SUBJECT: HYDROLOGIC ENGINEERING INPUT TO THE BEAVER VALLEY-2 SER

Plant Name: Beaver Valley Power Station, Unit 2  
Licensing Stage: OL  
Responsible Branch: Licensing Branch No. 3; M. Ley, PM  
Requested Completion Date: July 27, 1984

HYDROLOGIC ENGINEERING INPUT  
TO THE BEAVER VALLEY POWER STATION UNIT 2 SER

2.1  
 FIGURE 4-32 OHIO RIVER DRAINAGE AREA

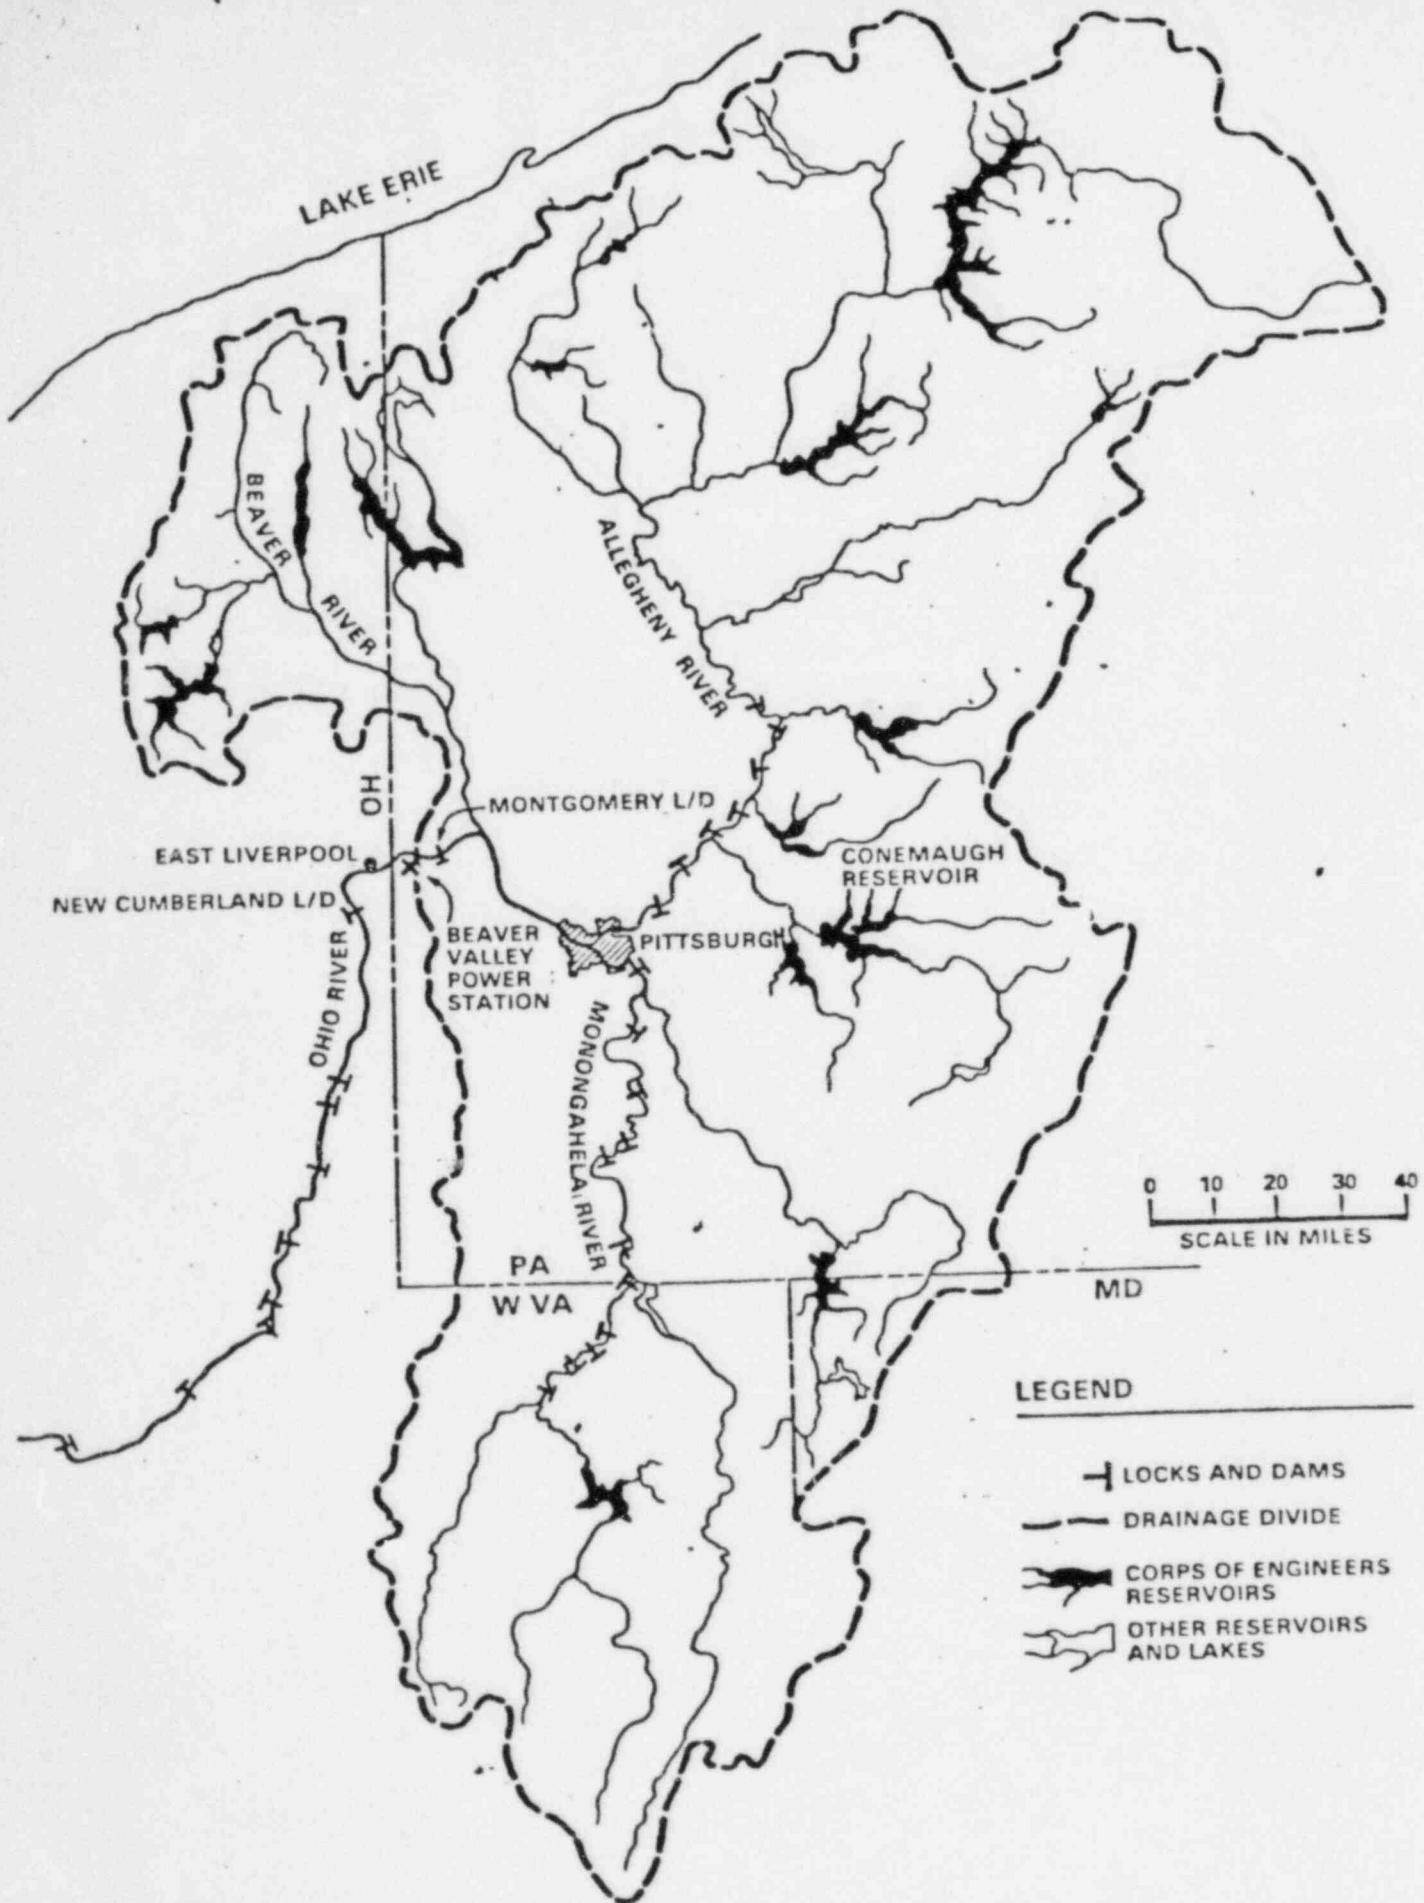
As shown in Figure 2.1, the Beaver Valley Power Station (BVPS) is located in southwest Pennsylvania about 5 miles east of East Liverpool, Ohio, and about 25 miles northwest of Pittsburgh<sup>h</sup>, Pennsylvania. The station is on the south side of the Ohio River adjacent to the New Cumberland Pool about 3.0 river miles downstream of the Montgomery Lock and Dam and 19.7 miles upstream of the New Cumberland Locks and Dam. The normal water level in the New Cumberland pool is maintained by the U.S. Army Corps of Engineers at elevation 664.5 feet above mean sea level (msl). By comparison, the station finished grade elevation varies from 730 ft-4 in msl to 735 ft msl except along the river where the station grade elevation slopes down to about 675 ft msl.

2.2  
 FIGURE 4.3-1 PRINCIPAL HYDROLOGIC FEATURES

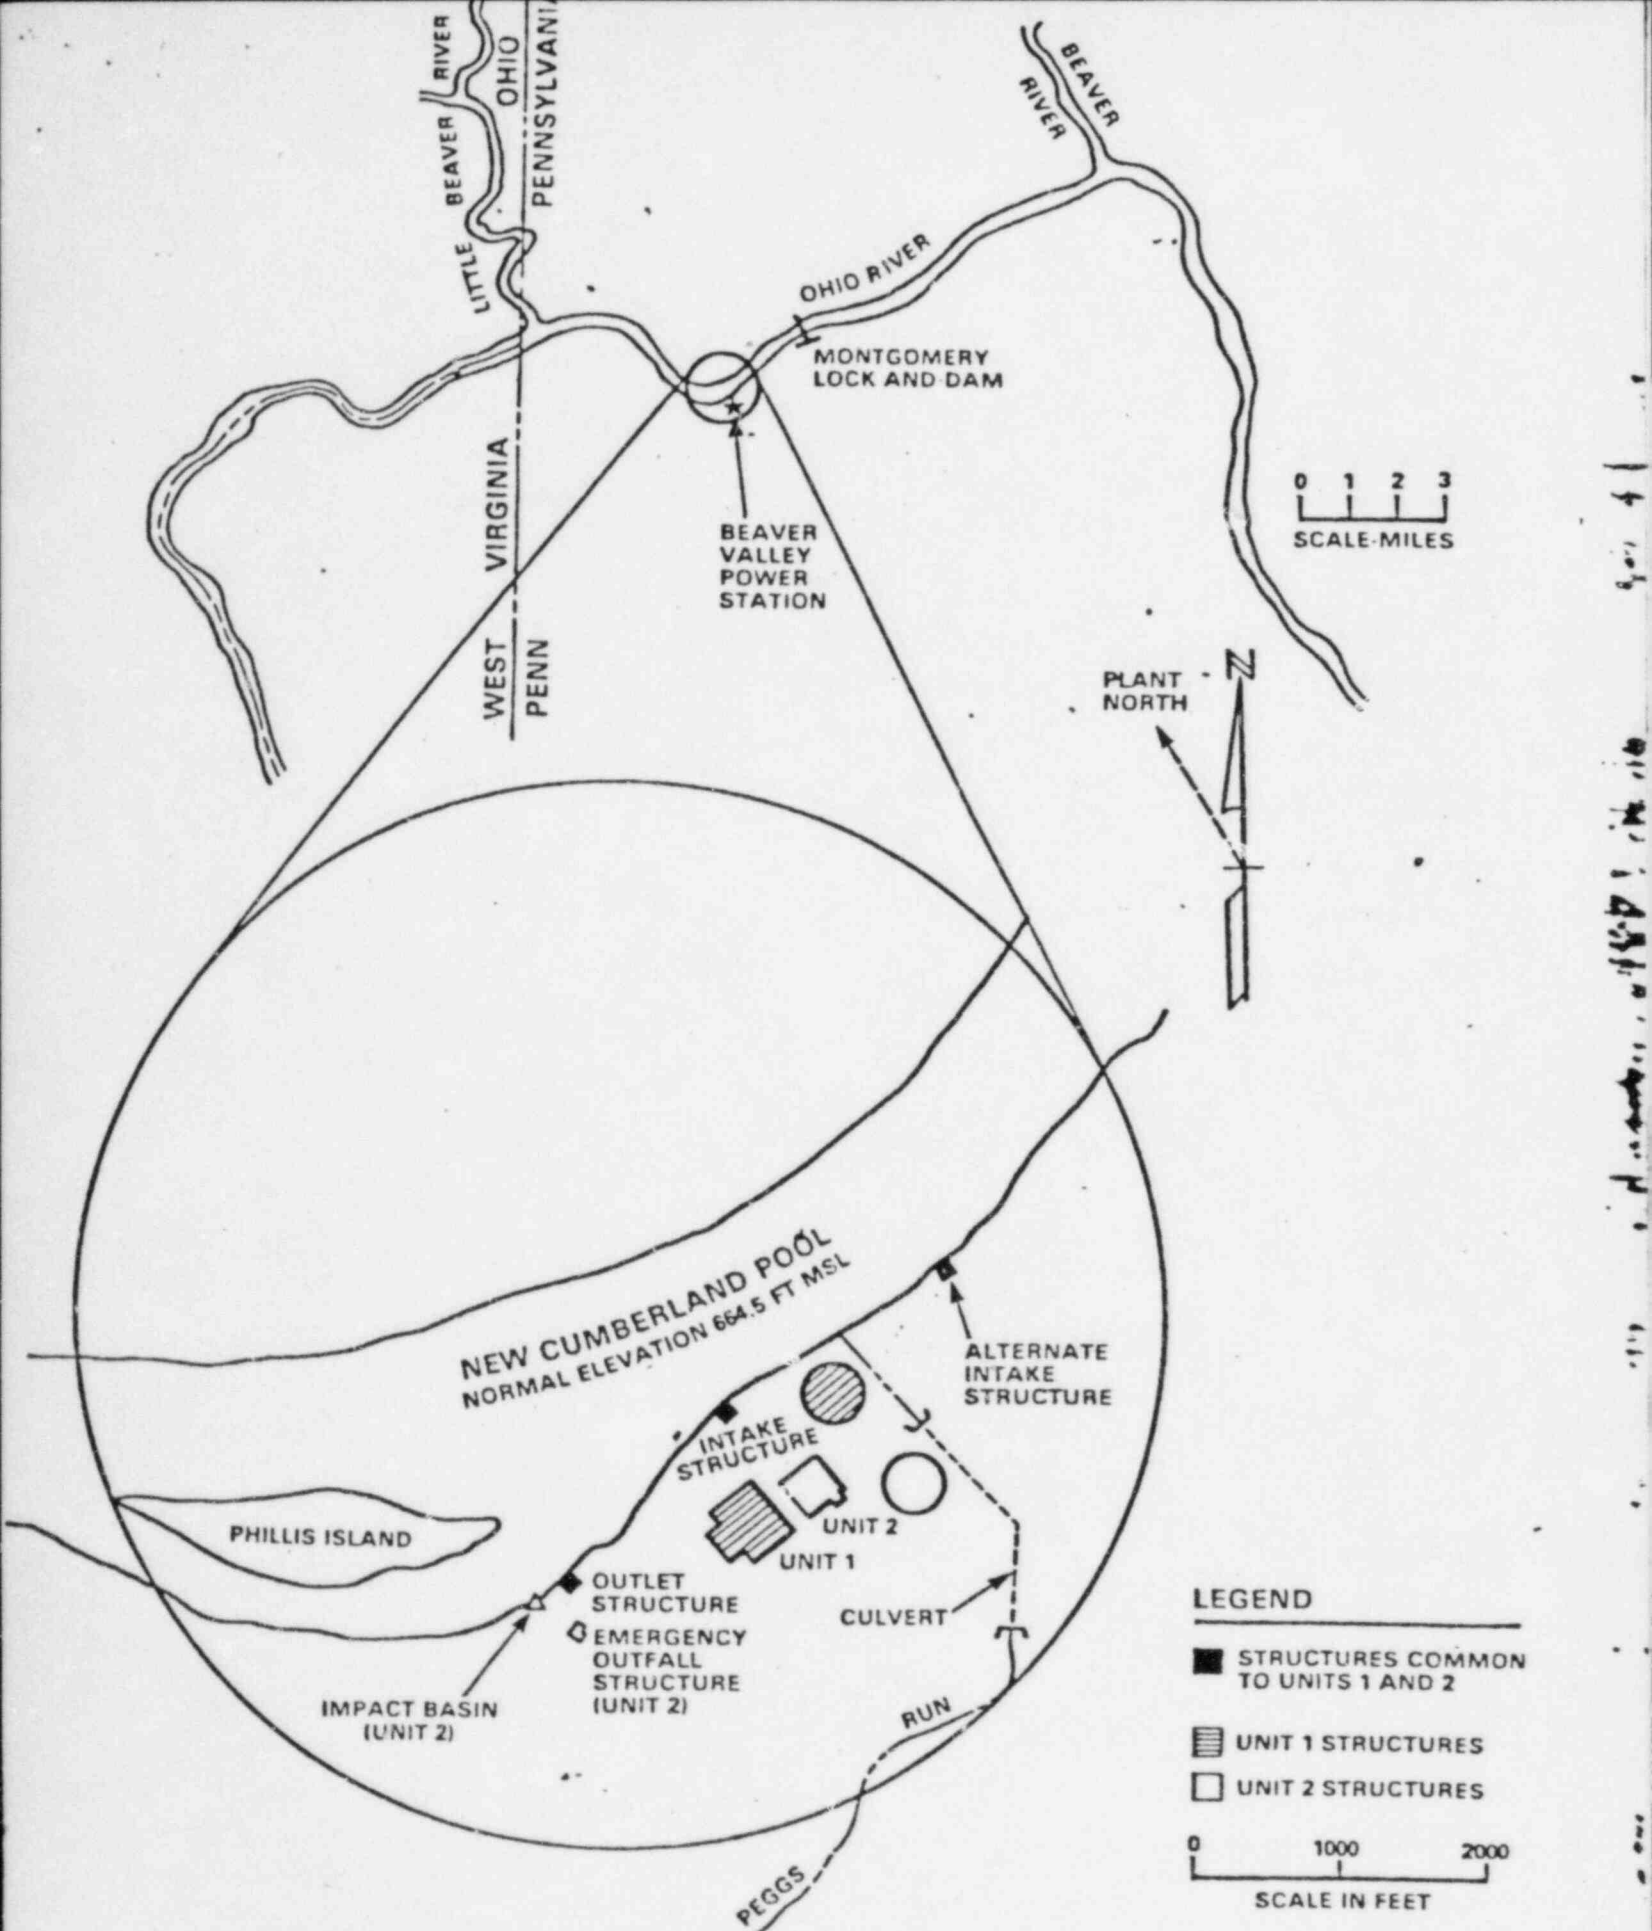
Significant hydrologic safety-related plant features include the intake structure, the alternate intake structure and the emergency outfall structure. The locations of these structures relative to other plant features are shown on Figure 2.2.

enclosed in a 15 ft diameter culvert so that the plant fill area could be extended across the Run. Location of the culvert is shown on Figure 2.2. The culvert empties into an open channel before entering the Ohio River. In analyzing the flood effects of a PMP event occurring over the Peggs Run drainage area, the applicant assumed that the 15 ft culvert was blocked. The applicant concluded that water levels in the vicinity of safety-related structures, due to flooding from Peggs Run, would be below the minimum station grade elevation of 730 ft-4 in msl.

The staff has reviewed the material presented in the FSAR and concludes that the applicant has not provided sufficient information to support its conclusion that flooding from Peggs Run will not affect safety-related buildings. The staff will complete its review following receipt, from the applicant, of responses to staff questions concerning flooding on Peggs Run.
